BEFORE THE WESTERN BAY OF PLENTY DISTRICT COUNCIL

AND of a resource consent application by Glen Isla Protection
Society Inc. under section 88 of the Resource
Management Act 1991 for the activities associated with
the construction and use of a coastal protection structure

STATEMENT OF EVIDENCE BY CRAIG DAVIS

25 JULY 2025

Figure 10 – Amended Cross-section Southern Wall 1.5m from Boundary

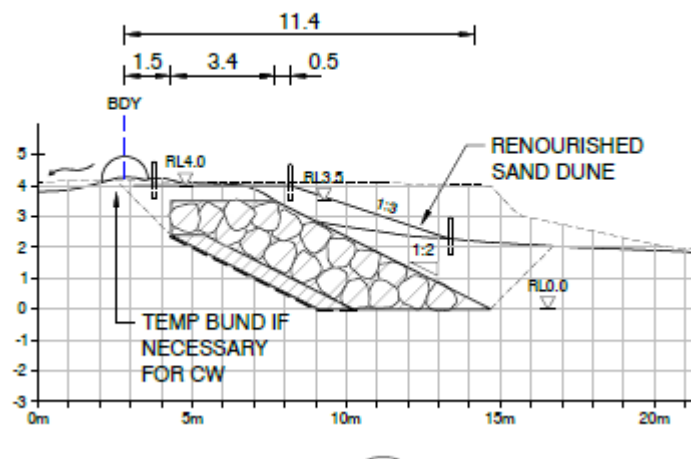
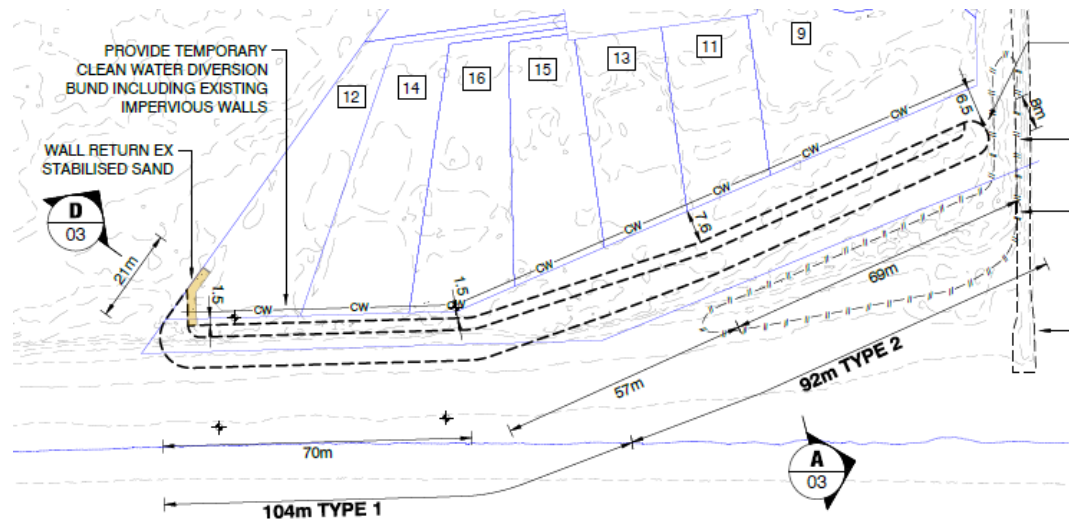
- 14.16 In response, to Mr Davidsons concerns I have examined decreasing the distance seaward of the southern section of the wall. I have prepared an alternate layout with the wall just 1.5m from the property boundaries. This would set the southern wall back 3.5 m and allow it to interact less with coastal processes for a longer time. I include relevant images from the revised plans as Figures 10 and 11 below and append a copy of the Plan (23028 Sheet 4 Revision A) to my evidence.

- 14.17 In setting a distance of 1.5m I have allowed a sufficient minimum distance to allow a notional width of backshore planting and/or possibly future access. At this reduced width, the conflict between having the dune planting and the provision for future access becomes more difficult. The final resolution of which can be resolved at that time. In addition, the 1.5m provides a minimum of construction access between the boundary and the extent of works. A rock revetment structure is not rectilinear in nature and comprised of large, very heavy, somewhat random shaped armour rock and as such there will be some variation in the precise extent of structure. The 1.5m also gives space for natural variability of the rear edge.

Figure 12 – Cross Section with Geotextile to RL3.5

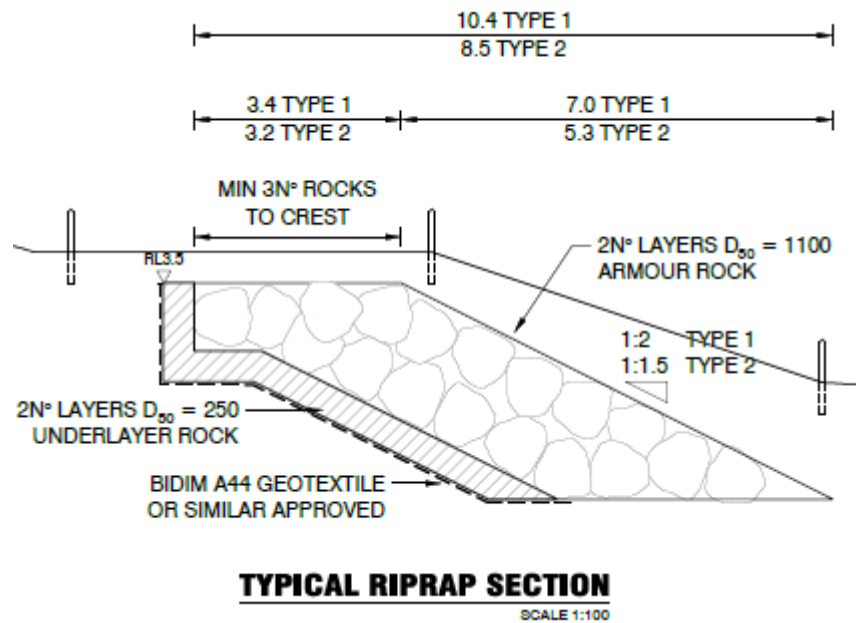
- 15.6 Mr Clarke also suggests the level of the Geotextile within the wall is increased above RL 2.0 primarily to address overtopping. This is a detailed design matter. Atypically the wall is being designed for a gradually worsening wave environment up to the stage additional work will need to be done. On this basis I agree with Mr Clarke that a detail for increased provision for overtopping is sensible. This matter will be resolved in detailed design however, a typical detail has been developed and agreed with Mr Clarke. Figure 12 below
